September, 2017

ERRATUM

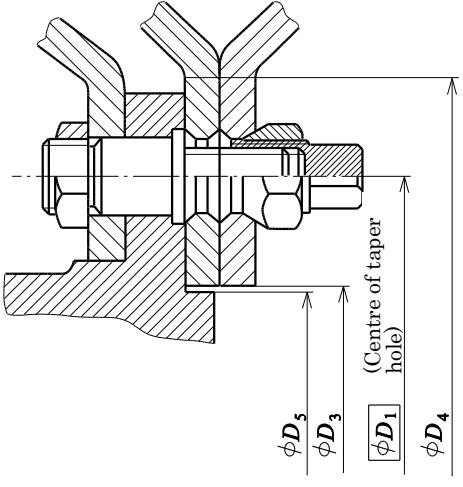
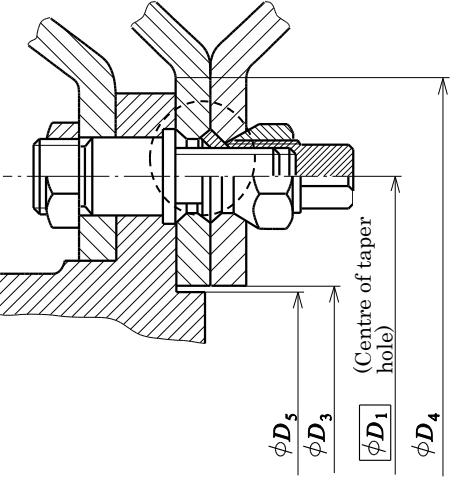
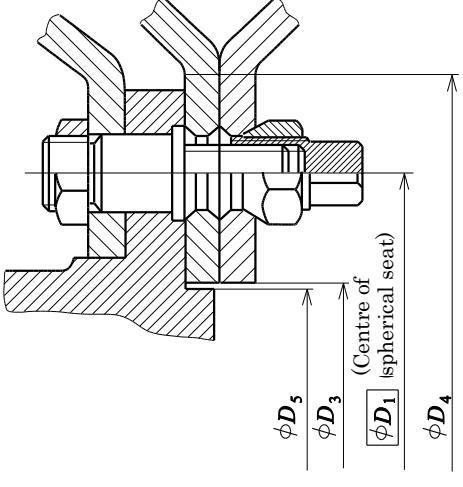
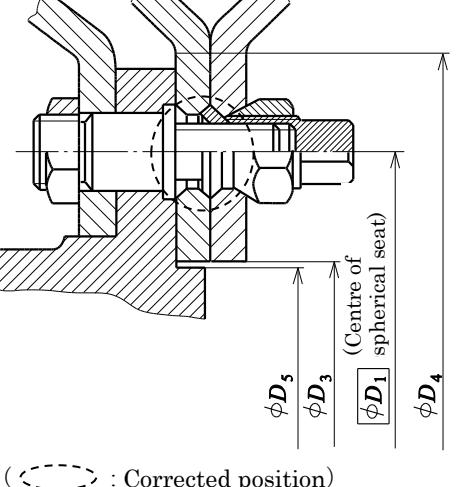
Page	Position	Error	Correct
7	5 Table 4 c)	 <p>Diagram illustrating the error in the fastening method. The error is shown as the distance from the center of the taper hole (ϕD_1) to the outer edge of the hub, indicated by dimension lines $\phi D_5 / \phi D_3$ and ϕD_4.</p>	 <p>Diagram illustrating the corrected fastening method. The corrected position is indicated by dashed lines, showing the distance from the center of the taper hole (ϕD_1) to the outer edge of the hub, indicated by dimension lines $\phi D_5 / \phi D_3$ and ϕD_4.</p>
11	Table 6 c)	 <p>Diagram illustrating the error in the fastening method. The error is shown as the distance from the center of the spherical seat (ϕD_1) to the outer edge of the hub, indicated by dimension lines $\phi D_3 / \phi D_3$ and ϕD_4.</p>	 <p>Diagram illustrating the corrected fastening method. The corrected position is indicated by dashed lines, showing the distance from the center of the spherical seat (ϕD_1) to the outer edge of the hub, indicated by dimension lines $\phi D_3 / \phi D_3$ and ϕD_4.</p> <p>(: Corrected position)</p>
